MIDWEST POOLED FUND PROGRAM

Progress Report - Second Quarter 2010 April 1st to June 30th

Midwest Roadside Safety Facility
Nebraska Transportation Center
University of Nebraska-Lincoln

August 2, 2010

Figure 8. rm43_jan07.pdf

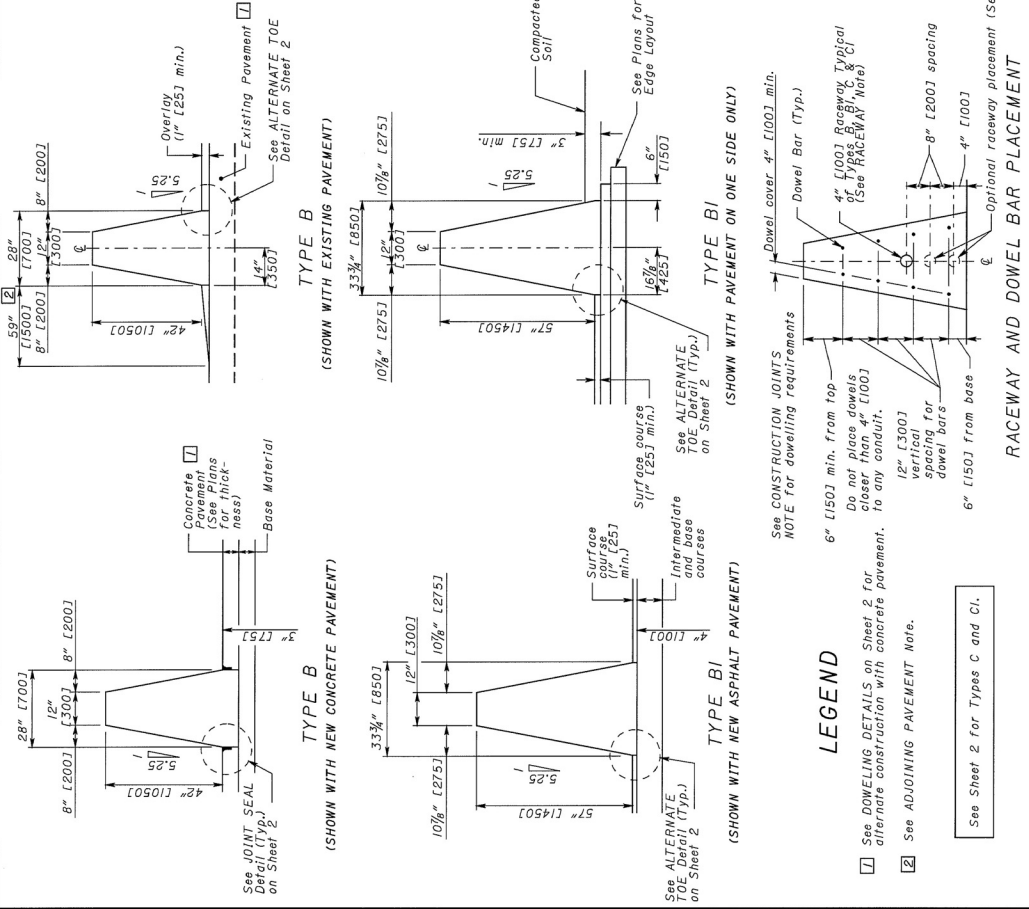
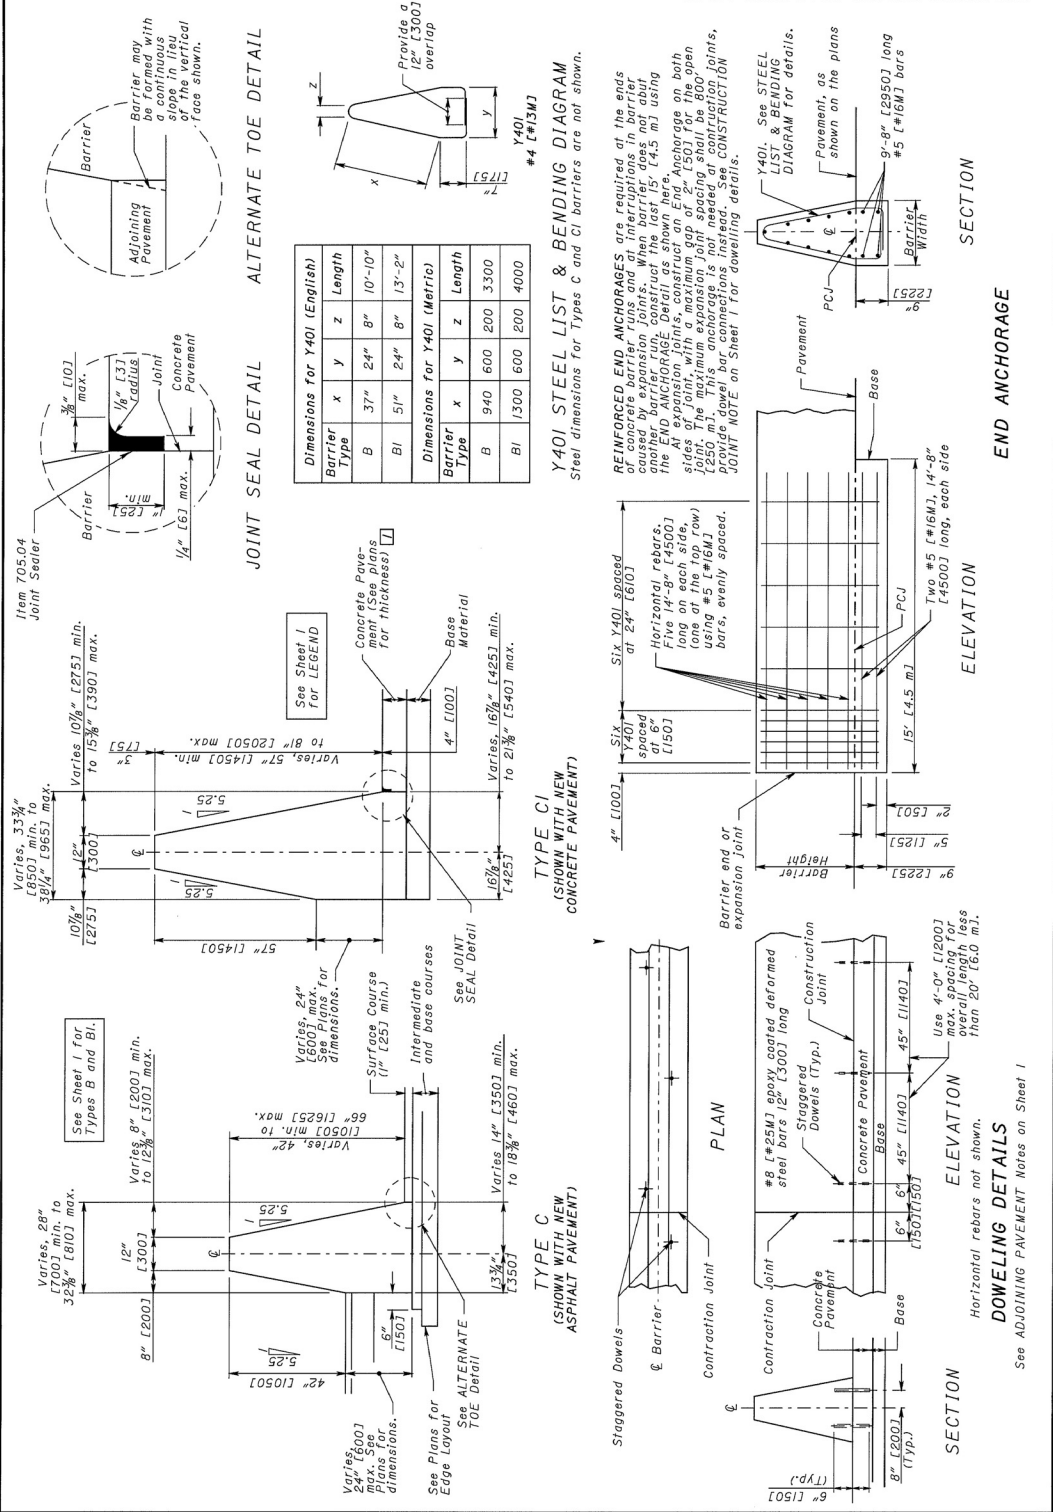
On page 2 of 2 in the pdf named rm43_jan07 there is a requirement to construct a reinforced end anchorages at all expansion joints. When the barrier wall abuts a inlet that requires a expansion joint on each end (I-2.1_jul05_v8.pdf) an end anchorage would be required on both sides. Our previous drawing rm-4.3_4-18-03.pdf did not require an reinforced end anchorage but the note on page 1 of 2 labeled End Anchorage required "all horizontal rebar through a permissible construction joint to continuously reinforce abutting barrier".

On page 2 of 2 in the pdf named rm43_jan07 there is a requirement to construct a reinforced end anchorages at all expansion joints. When the barrier wall abuts a inlet that requires a expansion joint on each end (I-2.1_jul05_v8.pdf) an end anchorage would be required on both sides. Our previous drawing rm-4.3_4-18-03.pdf did not require an reinforced end anchorage but the note on page 1 of 2 labeled End Anchorage required "all horizontal rebar through a permissible construction joint to continuously reinforce abutting barrier".

**** Per detail RM-4.3, January 2007, it is clearly and correctly stated that the reinforced concrete end foundation anchorages are required when an expansion joint or gap is to be placed within the single slope barrier system or when terminating the barrier at its end. When such barrier discontinuities are used in rigid barriers, the redirective capacity of the**

barrier can be greatly reduced due to its inability to form multiple yield lines throughout the section. As a result, a common practice has been to increase the size/quantity for the vertical and longitudinal steel reinforcement at the end sections as well as to increase the embedment depth of the concrete section, such as to integrate a grade beam or footing into the end section. At expansion joints, a narrow gap is often placed completely through the entire cross section, say 2 in. Per detail RM-4.3, April 2003, the OH DOT treated expansion joints in a similar manner to that now shown in the 2007 detail. However, the length of the embedded end anchorage has increased from 10 ft in 2003 to 15 ft in 2007, which is a reasonable modification.

**** In the OH DOT 2007 detail RM-4.3, it appears as though the longitudinal bars are now ended within the first concrete pour, and then 3/4-in. diameter by 18" long dowel bars are used to connect the two abutting vertical surfaces to one another. In this configuration, less than 9" of bar overlap would occur. It also may be difficult to place the dowel bars reasonable close to the existing bars and ensure continuity. The required overlap to ensure moment continuity would certainly exceed 9". If full moment continuity is expected across the construction joint, then it would be recommended to extend the longitudinal reinforcement of appropriate length through the joint. Then, the new longitudinal steel would splice to the exposed steel when the concrete placement operations were continued. If the dowel joint detail is still desired, it would be necessary to ensure that moment continuity and adequate bar development is provided across the joint.**

Figure 12. rm-4.3_4-18-03.pdf

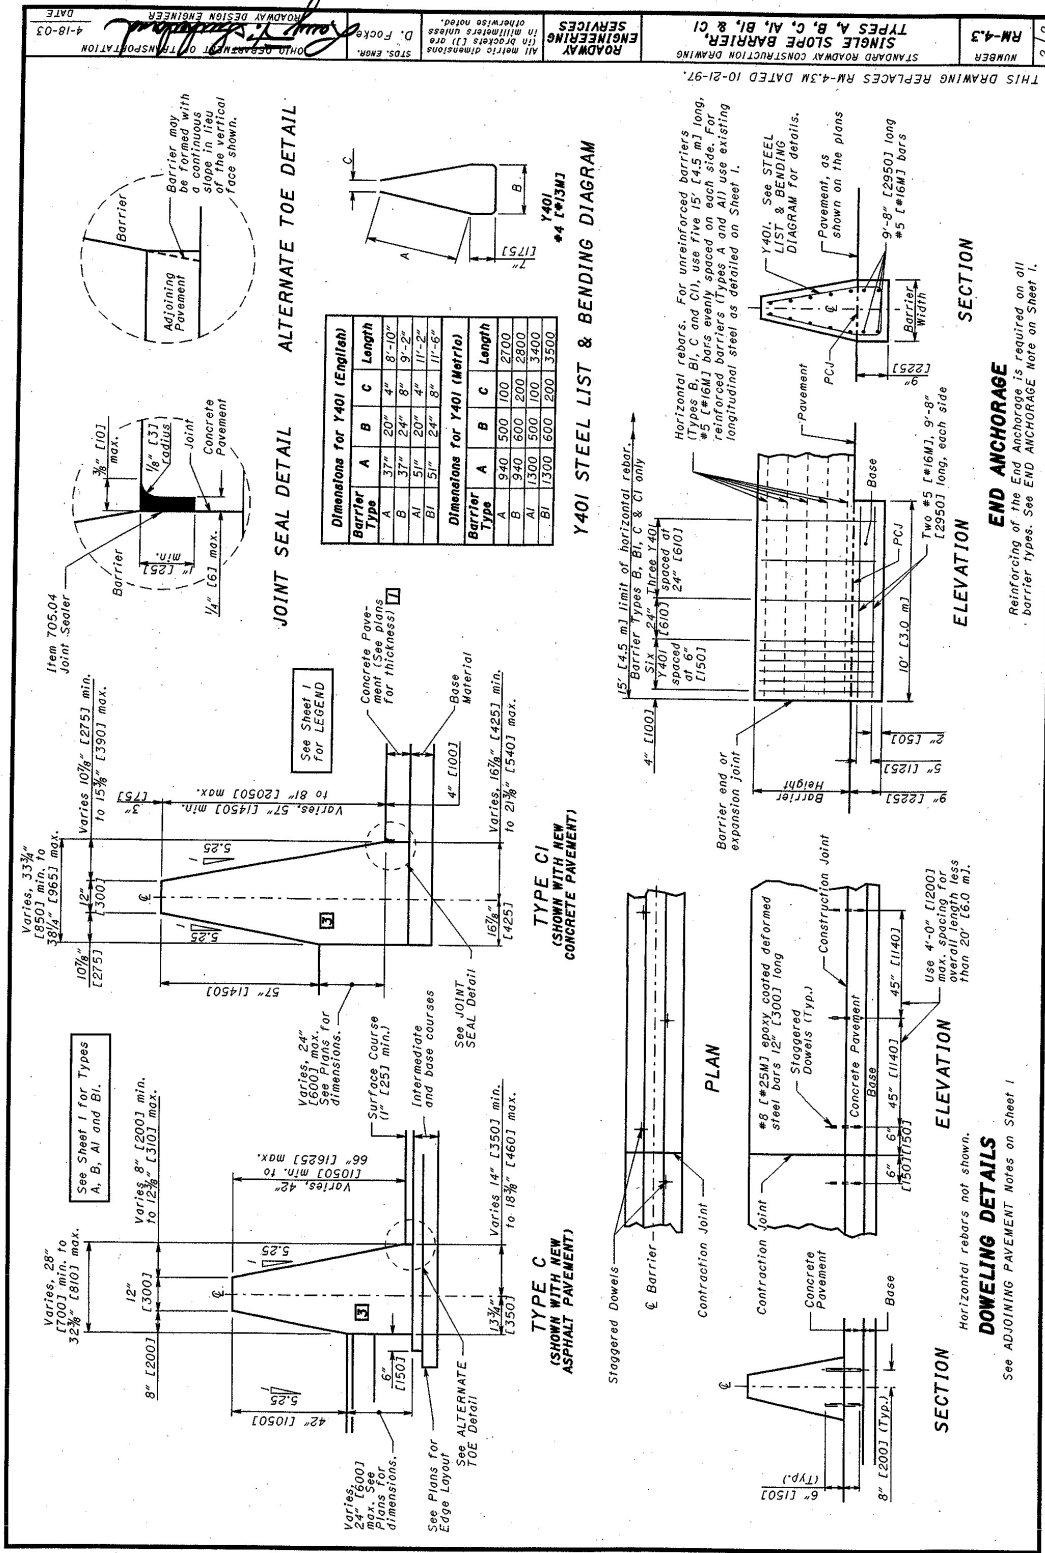
Do you have any information or testing on why this change would have been made?

**** Per detail RM-4.3, April 2003, it is clearly and correctly stated that the end longitudinal steel reinforcement is to be carried across the construction joint in a continuous manner. This treatment is often handled by leaving exposed rebar segments of sufficient length out of the end of the cast-in-place or slip-formed barrier section. When the concrete construction is eventually continued, new longitudinal rebar are tied to the exposed bars and covered with concrete. Full continuity is provided at these locations when sufficient lap length is provided to ensure moment transfer across construction joint locations.**

**** Unfortunately, I do not recall any prior discussions with Dean Focke, OH DOT regarding the change in details for the construction joints between 2003 to 2007. In addition, I am unaware of any test results regarding this issue. I went back to look at the original CALTRANS CAD details for the Type 60 family of barriers. When construction joints were shown, the footnote stated "Reinforcing steel shall extend continuous through construction joints." In addition, we assume full barrier capacity through construction joints since the steel is continuous (i.e., adequately lapped and developed) and concrete fills the gap. As such, no end anchorages and footings are needed at these construction joint locations.**
